City of Sugar Hill
Planning Staff Report
Town Center Overlay District (TCOD) Design Review 17-00267

DATE: March 1, 2017
TO: Mayor and Council, TCO Design Review Board
FROM: Planning Director *KA*
SUBJECT: D. West Hymryka – Sugar Hill Animal Hospital – 5305 Nelson Brogdon Blvd.

SUGAR HILL ANIMAL HOSPITAL ELEVATIONS

A2.0

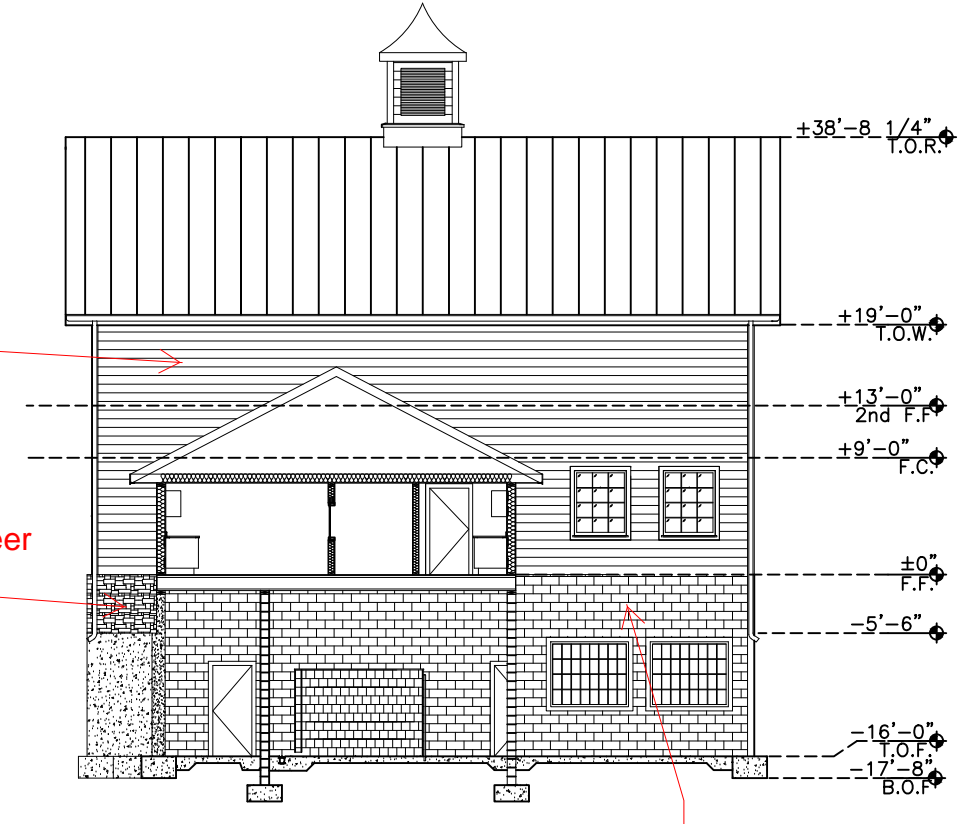
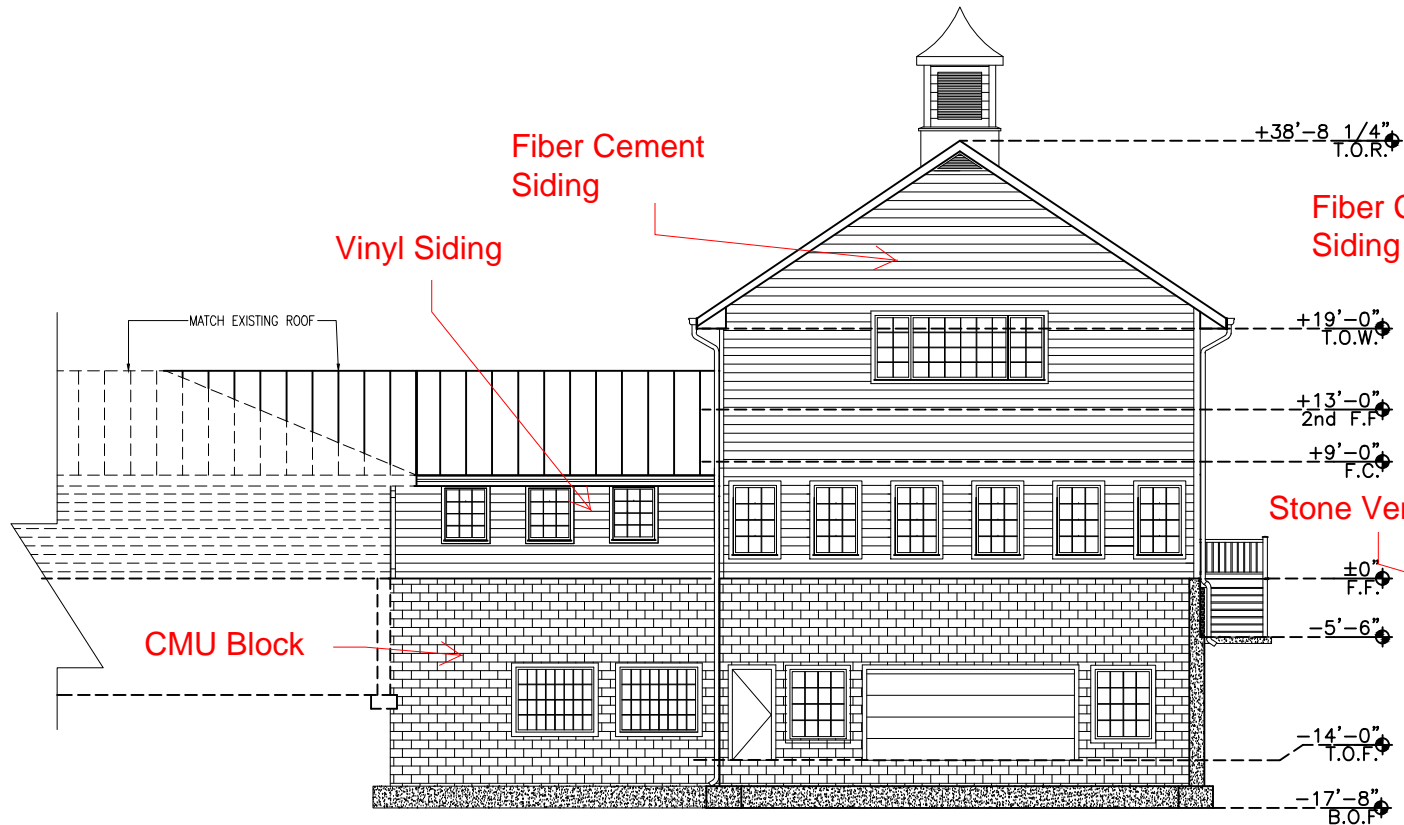
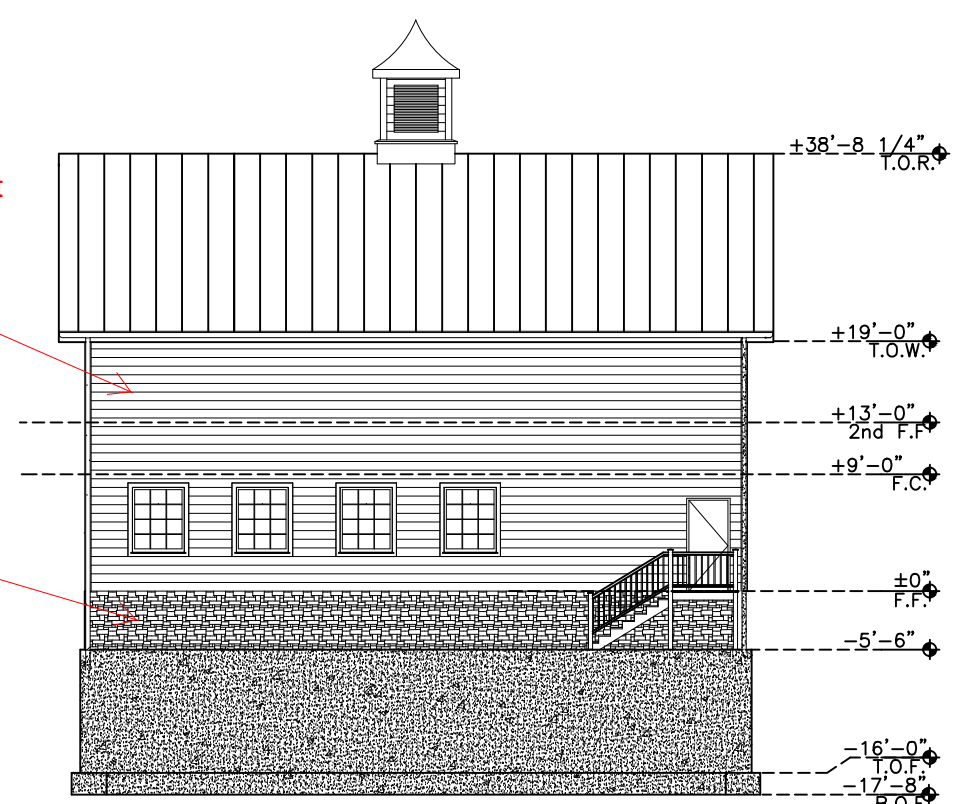
The applicant indicates that vinyl siding and CMU block will be used in order to match the existing building. The primary existing building is vinyl siding, and the previous addition to the building is painted brick with some portions covered with vinyl siding. CMU is specifically prohibited in the overlay, and siding must be high-grade fiber cement and must make up no more than 30% of any façade. Although the applicant indicates that a smooth material (CMU) is required for the areas directly adjacent to outdoor areas for the animals, it seems that other materials that are allowed within the overlay could be chosen. Additionally, the applicant has not provided sufficient justification for the vinyl siding. Therefore, the applicant should change these materials to those that are allowed within the overlay.

Approval of the overall design with stipulation that alternative material selections (to be approved by the City) are used in place of CMU and vinyl siding.
